ADDENDUM TO THE CONTRACT

Eaglecrest Learning Center
Contract No. E14-076

ADDENDUM NO.: **ONE**

DATE ADDENDUM ISSUED: **December 11, 2013**

S301

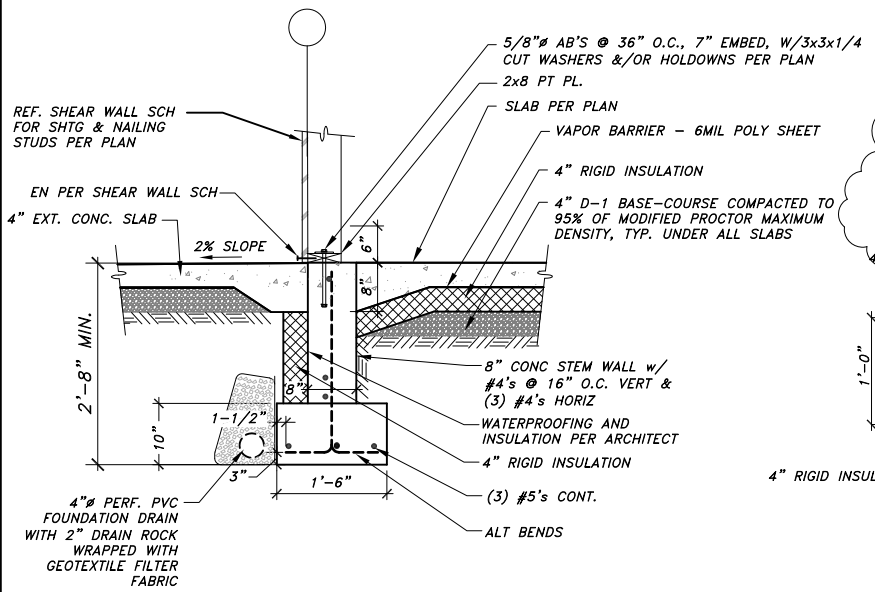
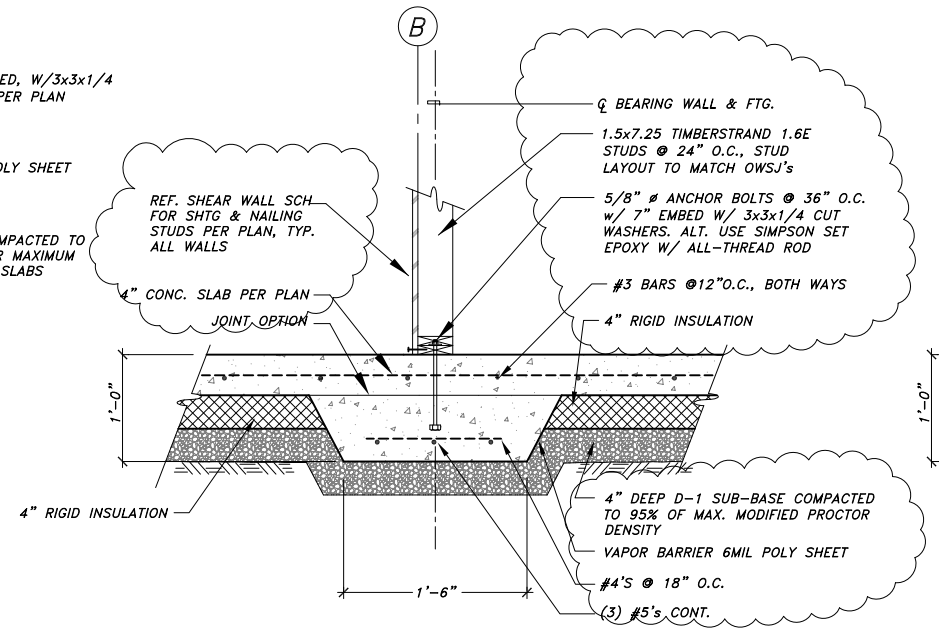
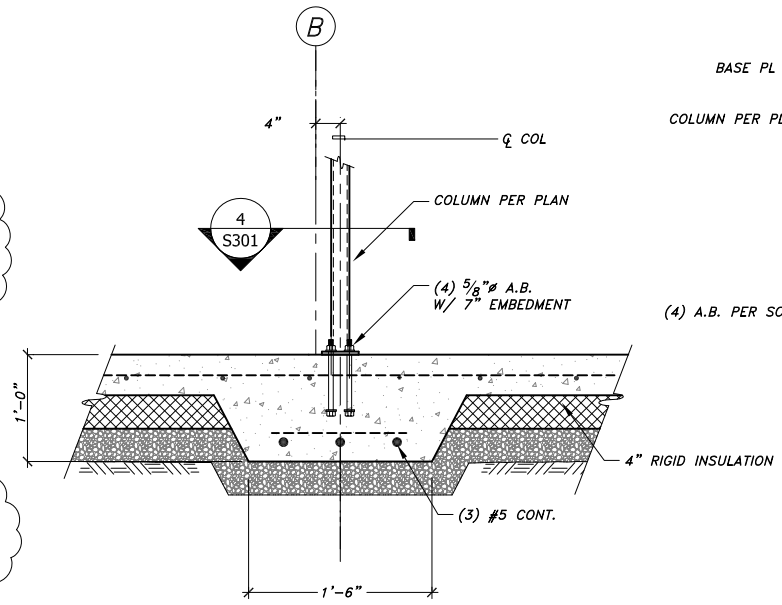
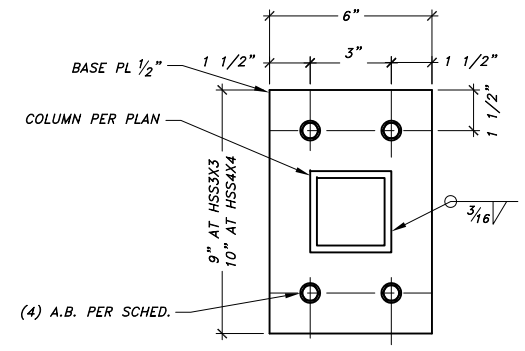
Item No. 26: SHEETS S301- FOUNDATION DETAILS and S302 – FOUNDATION DETAILS. ***Delete*** and ***replace*** with the attached Sheets S301, and S302, labeled Rev 1, dated 12/10/2013.
